SUNDRY NOTICES AND REPORTS ON WELLS
(DO NOT USE THIS FORM FOR PROPOSALS TO DRILL OR TO DEEPEN OR PLUG BACK TO A DIFFERENT RESERVOIR. USE "APPLICATION FOR PERMIT" (FORM C-101) FOR SUCH PROPOSALS.)
1. Type of Well: Oil Well [] Gas Well [X] Other
2. Name of Operator
EOG Resources, Inc.
3. Address of Operator
104 South Fourth Street, Artesia, NM 88210
4. Well Location
Unit Letter K : 1760 feet from the South line and 1350 feet from the West line
Section 7 Township 10S Range 34E NMPM Lea County
11. Elevation (Show whether DR, RKB, RT, GR, etc.)
4217'GR

EOG Resources, Inc. plans to plug and abandon this well as follows:

Operator: EOG RESOURCES INC P.O. Box 2267 Midland, TX 79702	OGRID: 7377
	Action Number: 83093
	Action Type: [C-103] NOI Plug & Abandon (C-103F)

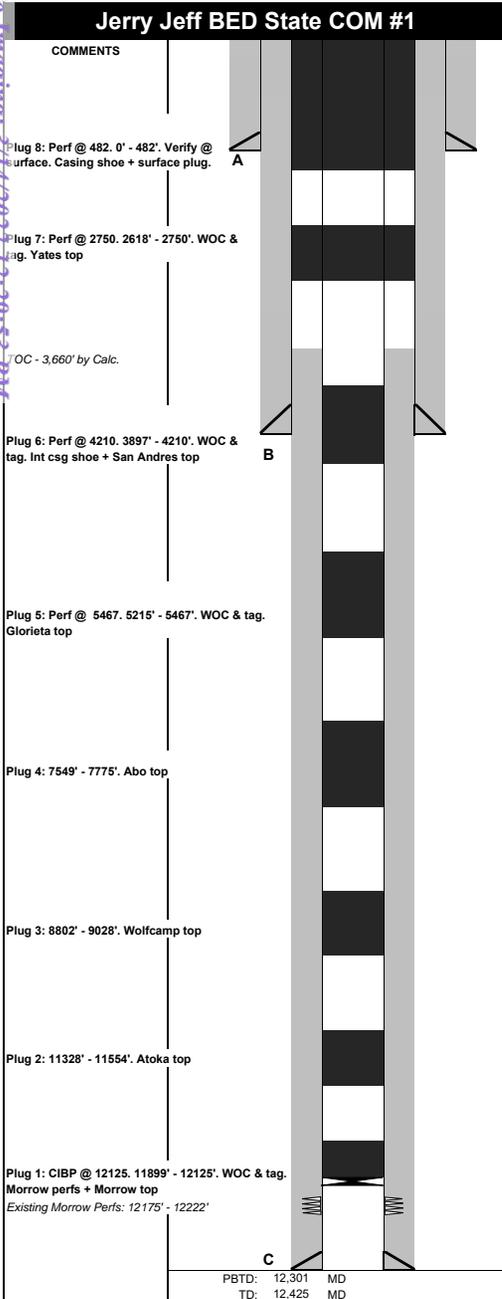
Wellbore schematics attached LPC Area Below ground marker send pics before backfilling hole
